**ZONING AMENDMENT &  
SUBDIVISION STAFF REPORT****Date: July 6, 2017**

<b><u>NAME</u></b>	Merrill P. Thomas Co., Inc
<b><u>SUBDIVISION NAME</u></b>	Government and Dexter Street Subdivision, Revision and Addition to
<b><u>LOCATION</u></b>	1459 & 1465 Government Street (Southeast corner of Dexter Avenue and Government Street)
<b><u>CITY COUNCIL DISTRICT</u></b>	District 2
<b><u>PRESENT ZONING</u></b>	B-2, Neighborhood Business District and R-3, Multiple Family District
<b><u>PROPOSED ZONING</u></b>	B-2, Neighborhood Business District
<b><u>REASON FOR REZONING</u></b>	To allow a restaurant and eliminate split zoning
<b><u>AREA OF PROPERTY</u></b>	2 Lots / 0.8 ± Acres - Subdivision 1 Lot / 0.2 ± Acres - Rezoning
<b><u>CONTEMPLATED USE</u></b>	Subdivision approval to create 2 lots and Rezoning from R-3, Multiple Family District, and B-2, Neighborhood Business District, to B-2, Neighborhood, to allow a restaurant and eliminate split zoning. <b>It should be noted, however, that any use permitted in the proposed district would be allowed at this location if the zoning is changed. Furthermore, the Planning Commission may consider zoning classifications other than that sought by the applic

## DETAIL SITE PLAN

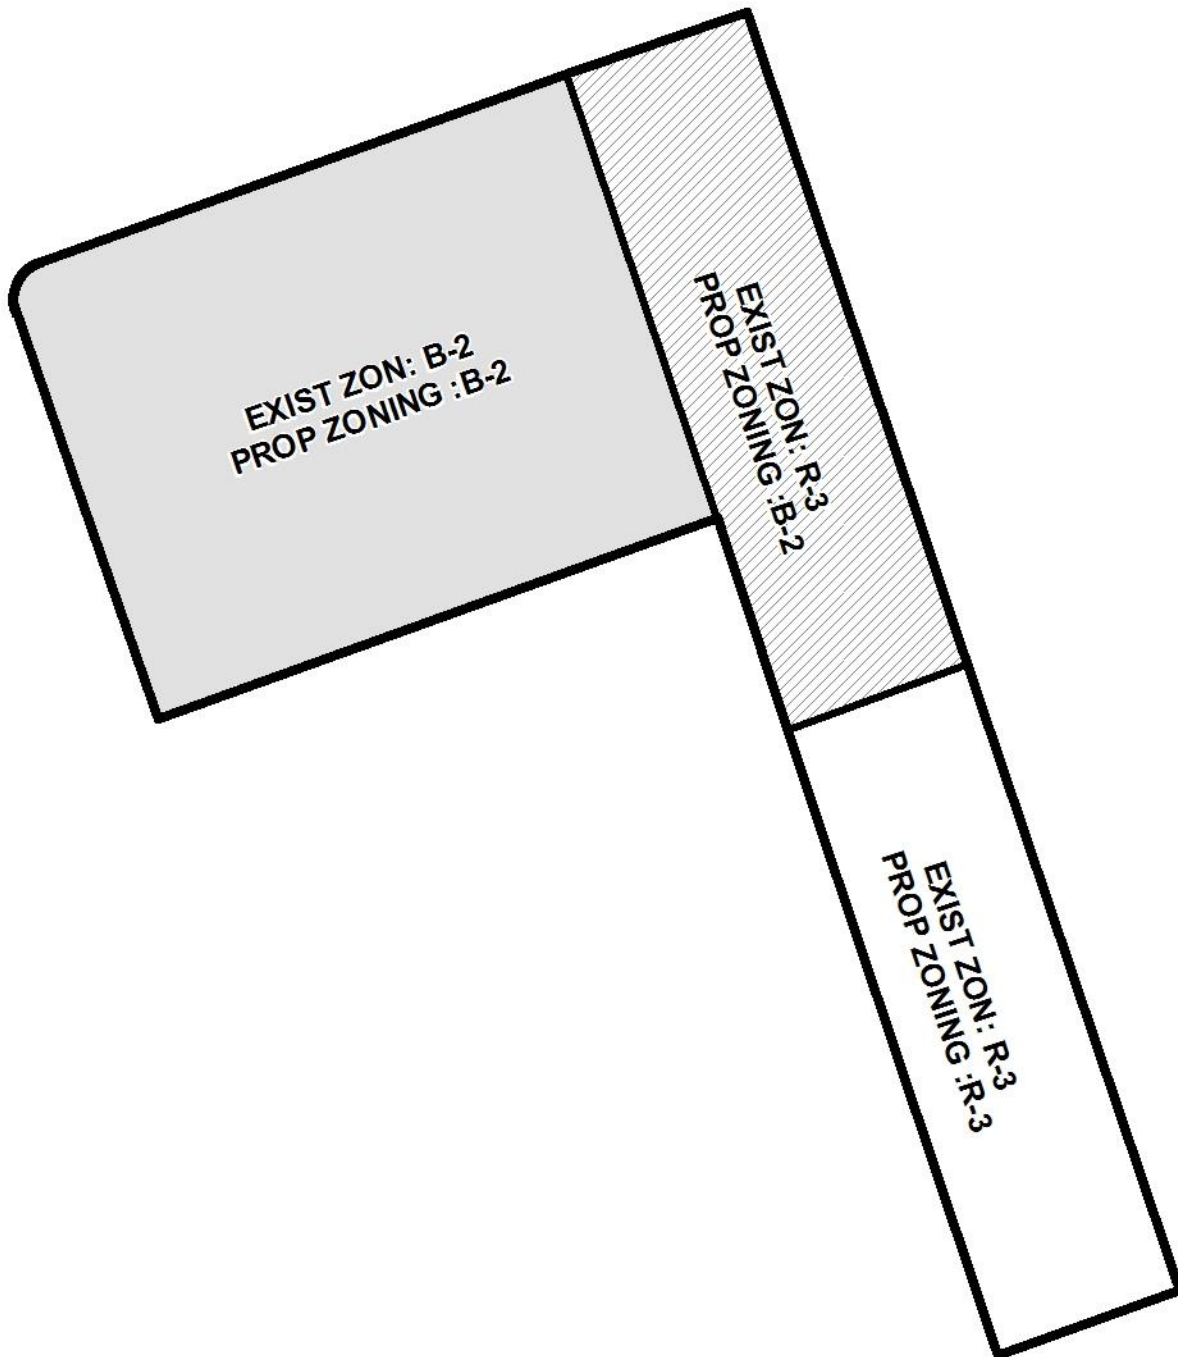
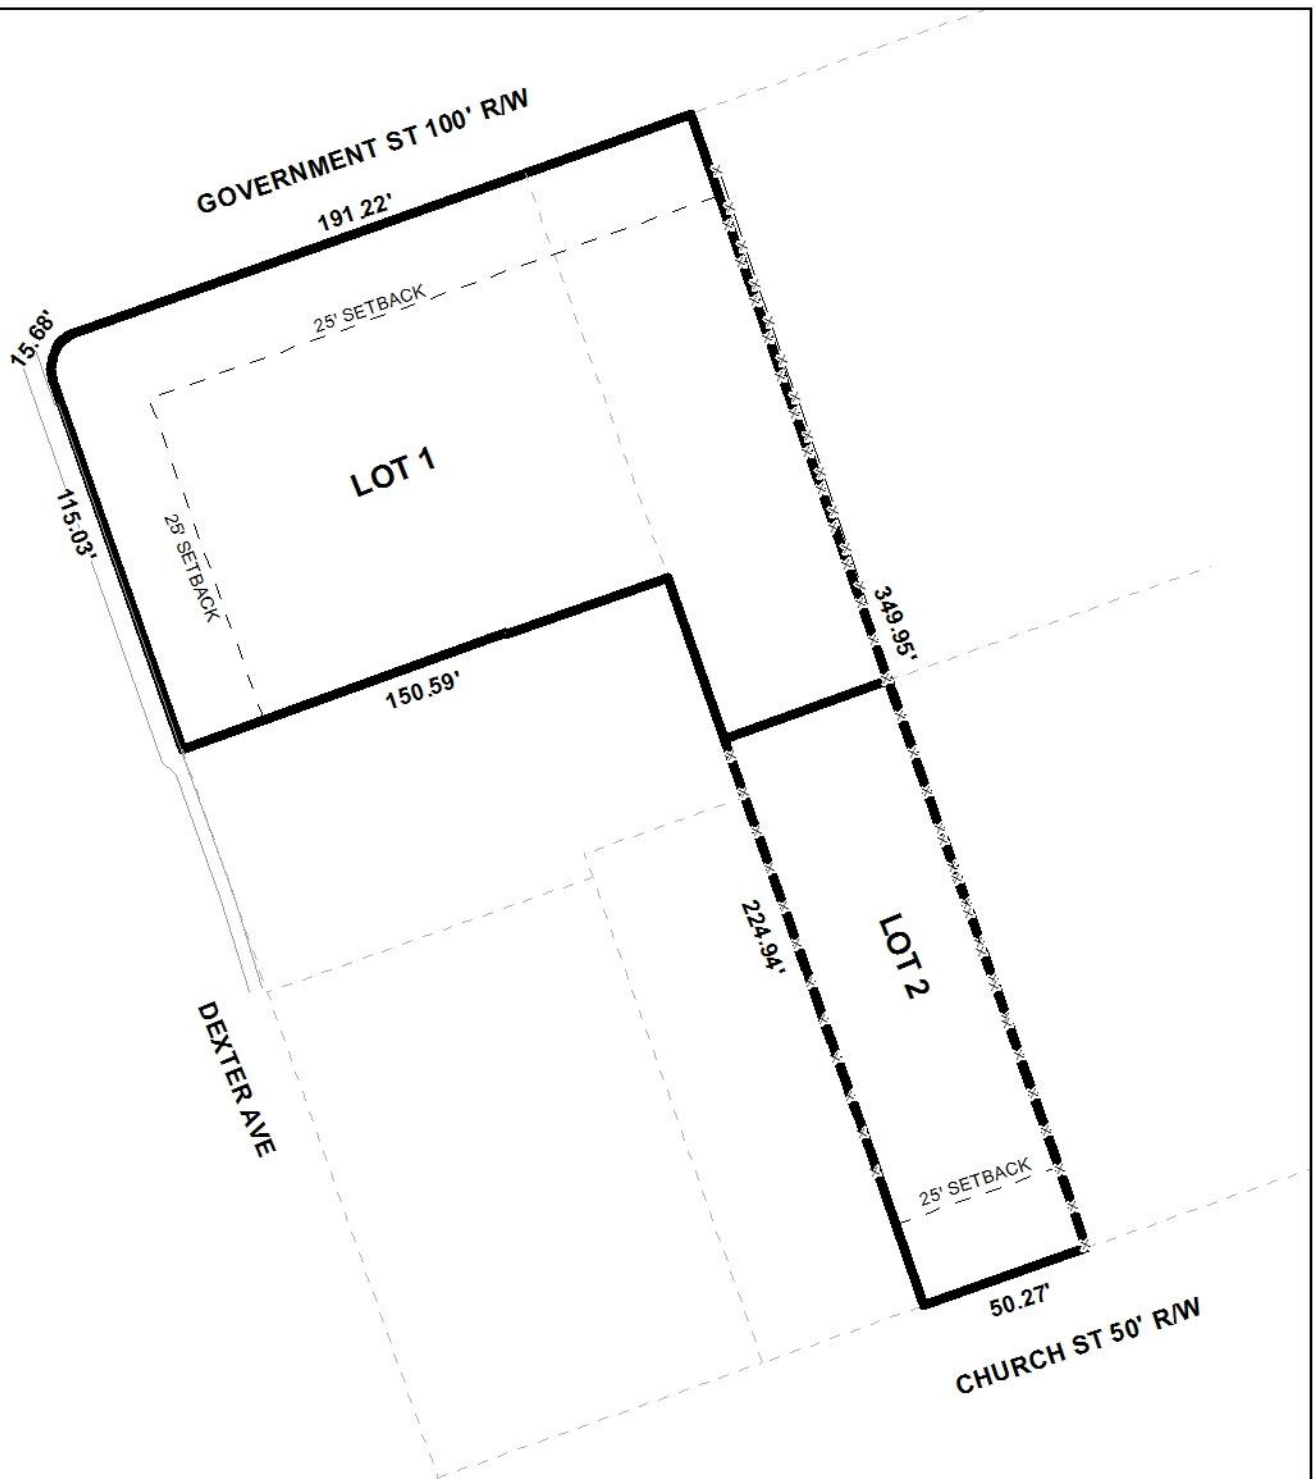
The proposed layout for development depicts the drive-through location for the restaurant on the Government Street side of the proposed building, with the stacking lane within the front 25-foot setback, and the pick-up window facing Dexter Avenue.

The site plan submitted does not depict any tree and landscape calculations, therefore staff cannot determine if the site meets the minimum tree and landscaping requirements. A site plan depicting full tree planting and landscaping requirements per Section 64-4.E of the Zoning Ordinance will be required at the time of submission for building permits.

While the proposed development will result in the closure of two driveways along Government Street, and the provision of a new neighborhood service, a proposed deceleration lane on Government Street will result in the removal of one existing live oak tree within the public right-of-way. The proposed curb-cut to Dexter Avenue will also require the removal of one existing live oak within the public right-of-way. It should be noted, the removal of the two live oak trees within the right-of-way will require Mobile Tree Commission approvals which may not be guaranteed. Thus, while access and circulation will be adequate for the proposed development, the relationship of the proposed commercial uses to the Government Street corridor, the historic district context of the site, and the proposed curb-cuts may potentially impact the historic nature of the corridor and the neighborhood.

A dumpster with an enclosure is depicted on the site plan. If approved, dumpster placement must comply with Section 64-4.D.9. of the Zoning Ordinance.

A 6' privacy fence is depicted on the site plan, screening the site from residentially zoned properties along Church Street.

A sidewalk will be required as part of the proposed new development, and are depicted on the submitted site plan.
